PROJECT: RENOVATION AT SSS MAIN BUILDING-ESPRESSO CAFÉ-LIBRARY

QUERIES/CLARIFICATIONS RAISED DURING THE PRE-BID CONFERENCE:

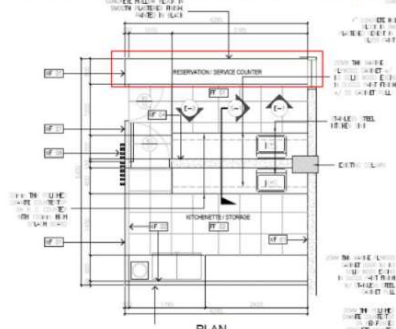
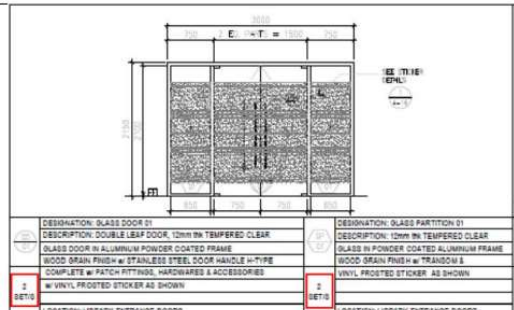
Query/Clarifications	TWG/BAC Reply
13	Are the required brochures for certain material specifications to be submitted as part of the bidding documents, or are they only required from the winning bidder? Additionally, are swatches also required during bid submission?"	Yes. The brochures and swatches are required from the winning bidder only.
14	Will there be a template provided for the SPA?	No.
15	Is it required to attend or participate in the prescreening of documents and what documents are needed?	No. However, the bidders are encouraged to avail of the said activity.
16	Who will be the contact person for the site inspection?	The BAC Secretariat shall be the contact person for the site inspection.
